BACKGROUND DATA

Project Description

The applicant proposes a six-story office building containing offices, ground-level retail, and parking located within the structure.

DESIGN REVIEW PROCESS

Figure 4. Concept sketches of sidewalk treatment on Dexter Ave N.

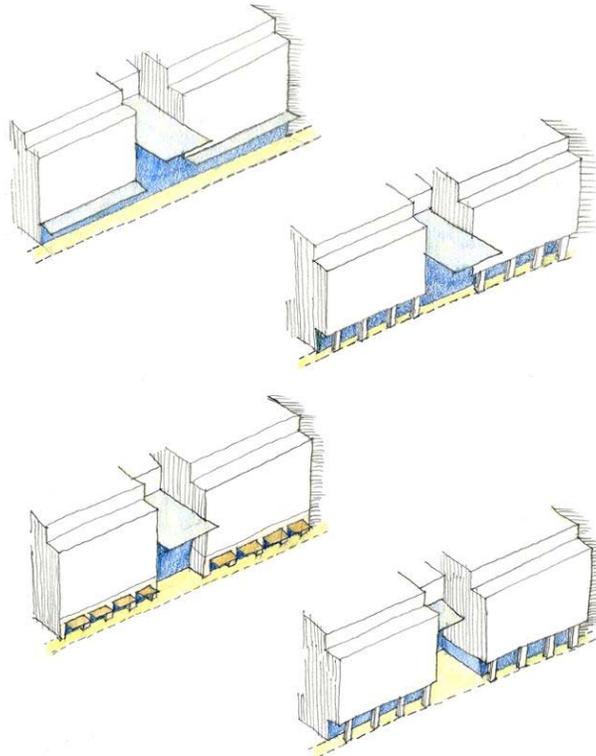
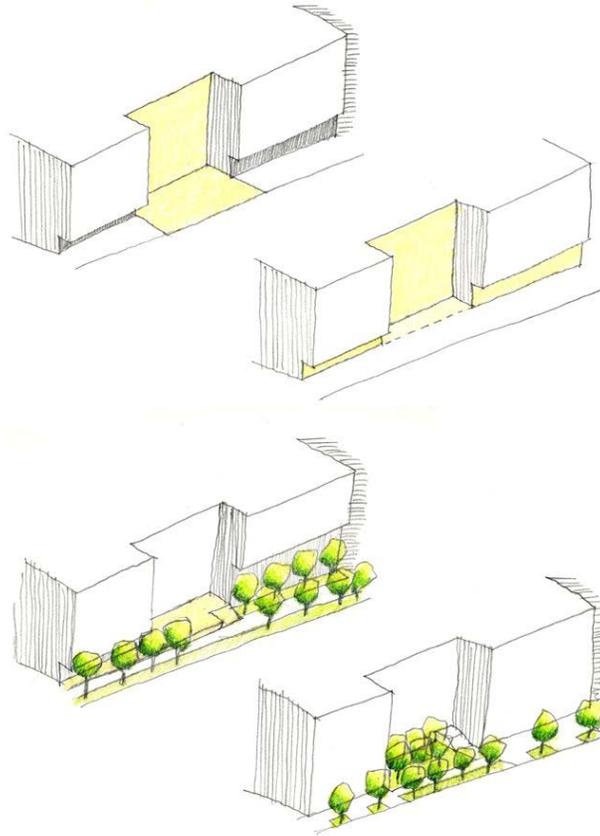
Regarding the winter garden, Mr. Niehoff referenced the lobby of the LMN-designed [Bellevue Civica Office Commons](#), stating that its dimensions and overall scale are similar. He also showed images of 1101 Madison on First Hill, and images of Redmond Town Center, noting their successful use of lighting under pedestrian canopies. He showed rough sketches of how the building might relate to sidewalks on Dexter and on Aurora (see **Figure 4** and **Figure 5**). Two sketches feature pedestrian arcades along Dexter, which the architect disfavors.
